HISTORIC AND DESIGN REVIEW COMMISSION

2017-623

925 LAMAR ST

Rear Addition

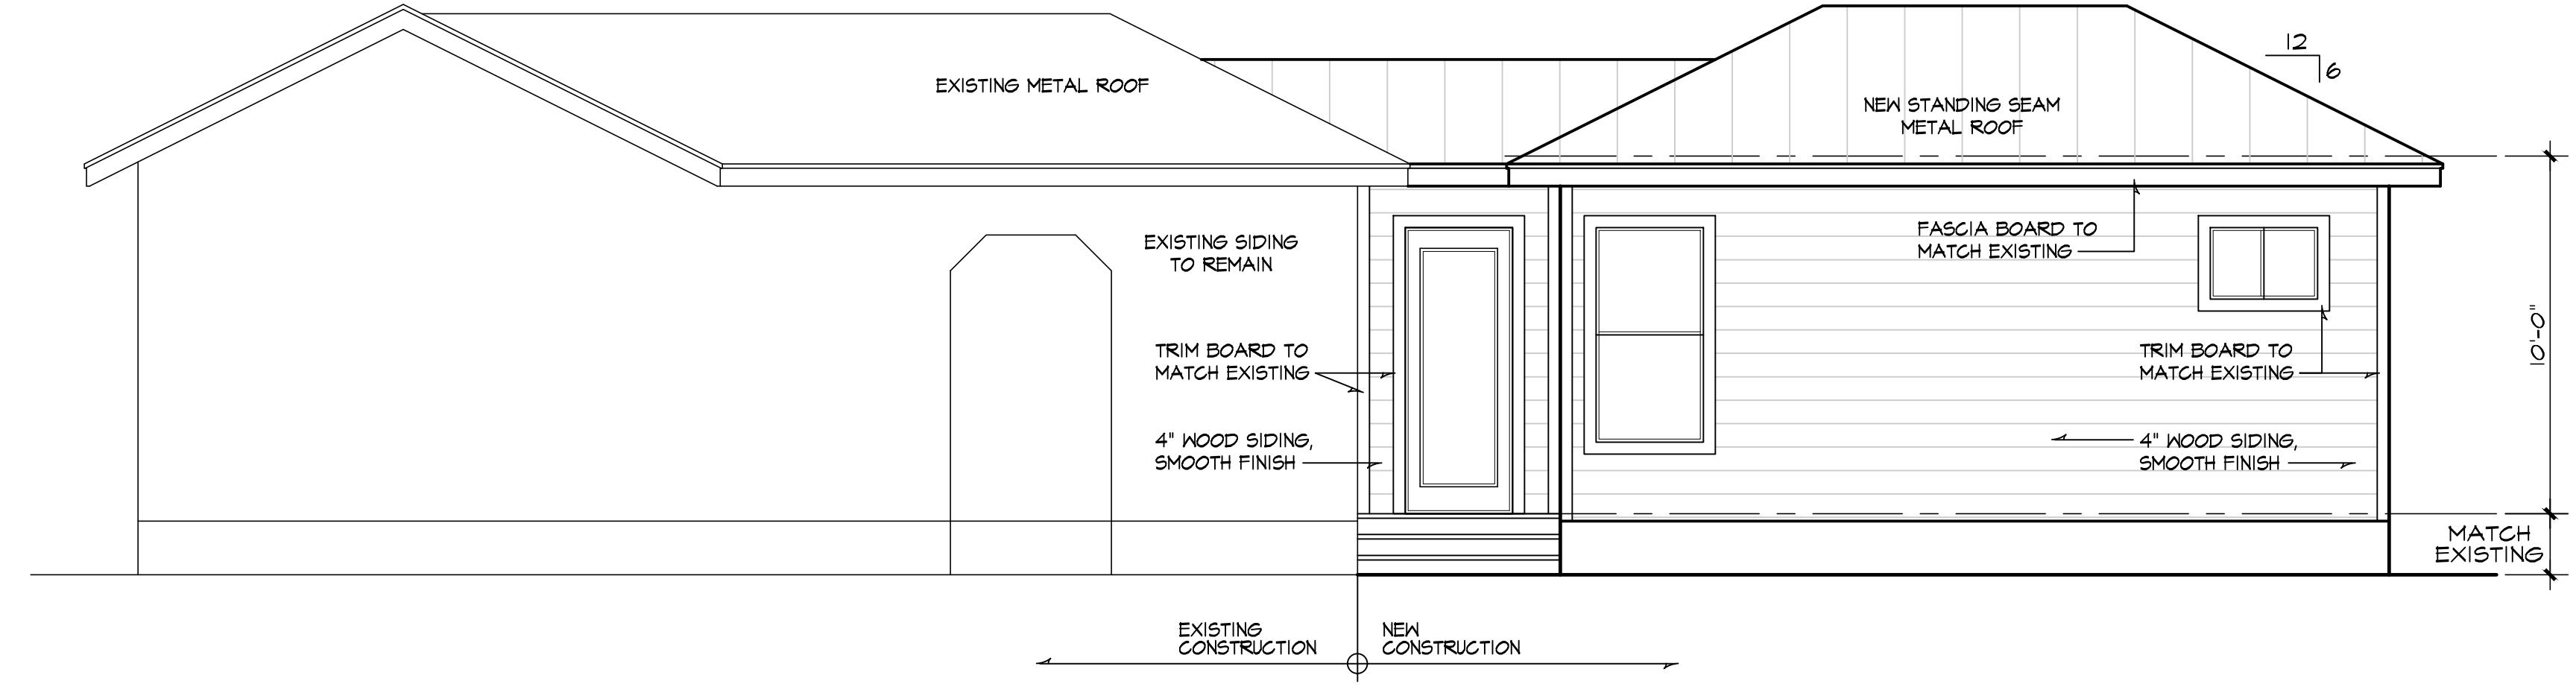
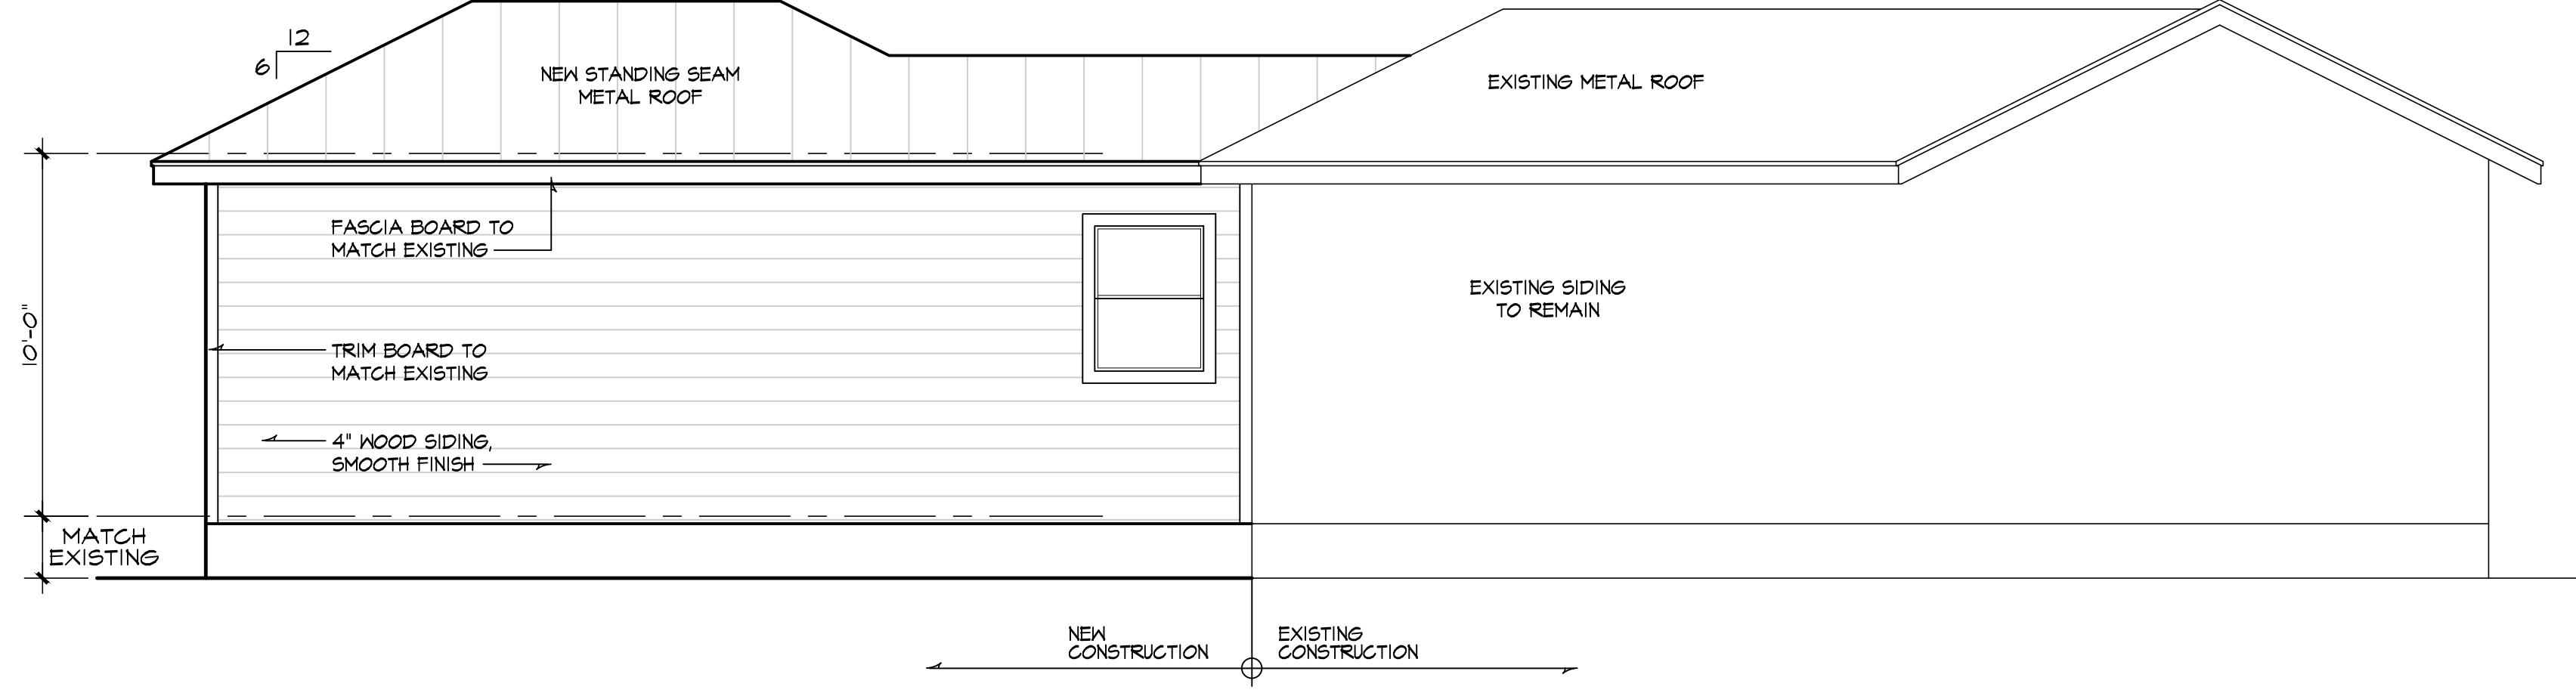
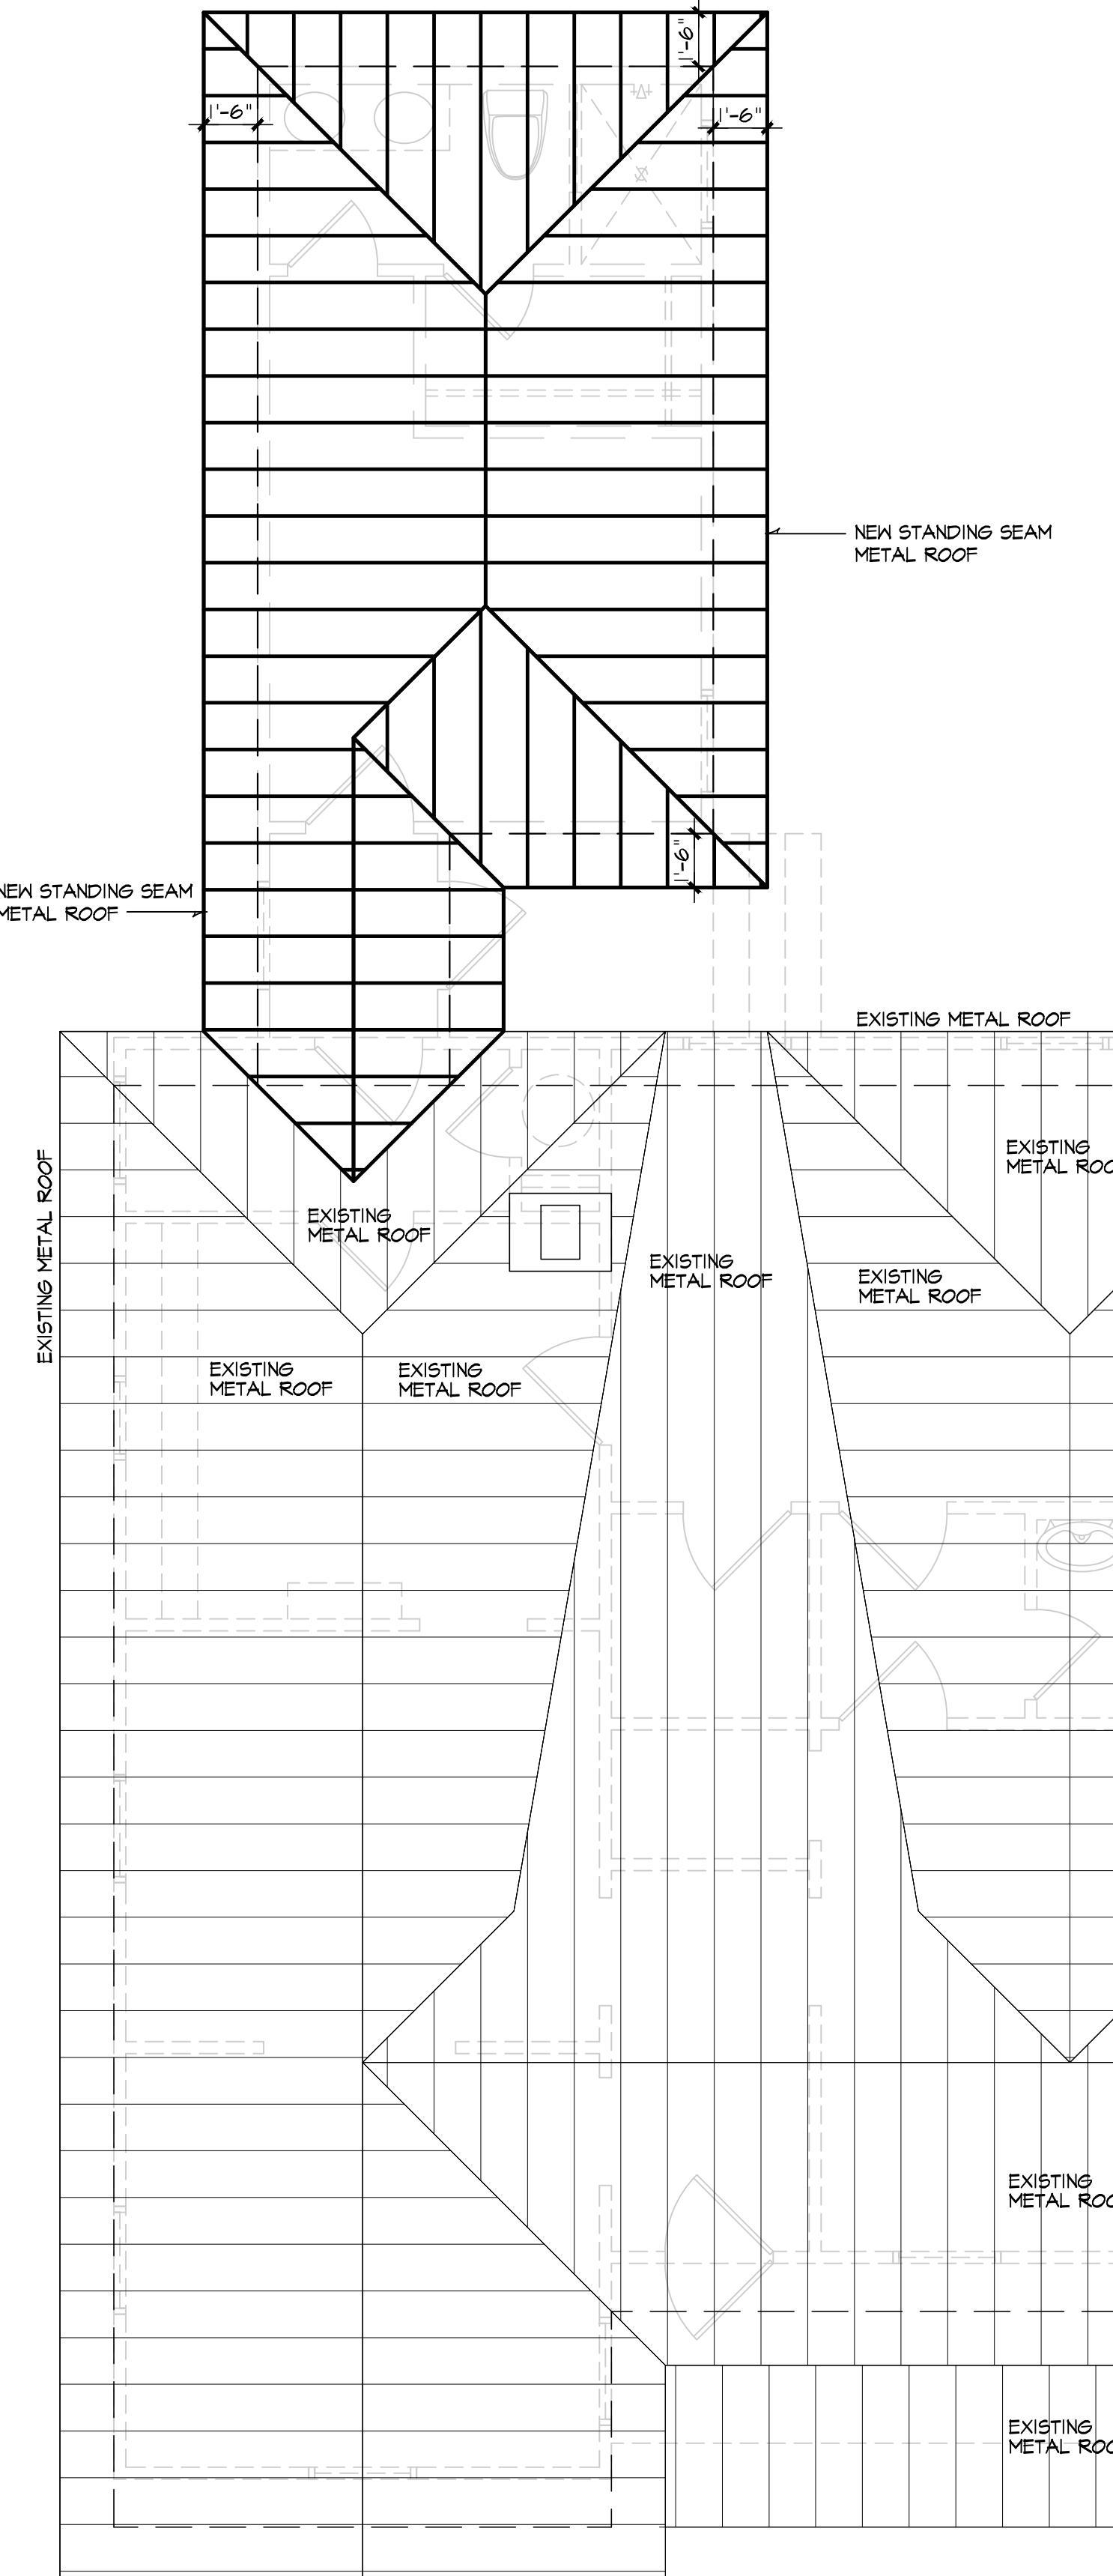
- b. REAR ADDITION – The Guidelines for Additions 1.A. states that additions should be sited to minimize visual impact from the public right of way, should be designed to be in keeping with the historic context of the block, should utilize a similar roof form and should feature a transition between the old and the new. The applicant has proposed for the rear addition to feature a hipped roof that is to feature a ridgeline that per the construction documents is slightly greater than that of the primary historic structure. For a rear transition, the applicant has proposed for the width of the proposed addition to be subordinate to that of the historic structure and has proposed to construct the majority of the addition's massing separate from the massing of the historic structure. Staff finds that the addition should feature a roofline that is subordinate to that of the primary historic structure.

- d. MATERIALS – The applicant has proposed materials that include a standing seam metal roof, vinyl siding, wood windows, one aluminum window and one steel exterior door. Per the Guidelines for Additions 3.A.i., materials that are compatible with the architecture style and materials of the original structure should be used on the addition. While currently found on the historic structure, the use of vinyl siding on the addition is not consistent with the Guidelines. Staff recommends the applicant use wood or a cememtitious siding to feature an exposure of four (4) inches and a smooth exterior finish.

- e. MATERIALS – Regarding materials, the proposed standing seam metal roof should feature panels that are 18 to 21 inches wide, seams that are 1 to 2 inches in height, a crimped ridge seam and a standard galvalume finish. A large ridge cap should not be used. Regarding windows, the applicant has proposed to install all wood windows. Regarding window installation, white manufacturer's color is not allowed, and color selection must be presented to staff. There should be a minimum of two inches in depth between the front face of the window trim and the front face of the top window sash. This must be accomplished by recessing the window sufficiently within the opening or with the installation of additional window trim to add thickness. Window trim must feature traditional dimensions and an architecturally appropriate sill detail. Window track components must be painted to match the window trim or concealed by a wood window screen set within the opening. Details on each should be submitted to staff for review.

- i. That the rear addition feature an overall height that is consistent with or subordinate to that of the primary structure as noted in finding b.
- ii. That the proposed standing seam metal roof feature panels that are 18 to 21 inches wide, seams that are 1 to 2 inches tall, a crimped ridge seam and a standard galvalume finish as noted in finding e.
- iii. That the addition feature wood or a cementitious siding that features an exposure of four inches and a smooth exterior finish as noted in finding d.
- iv. That the proposed wood windows follow specifications noted in finding e.
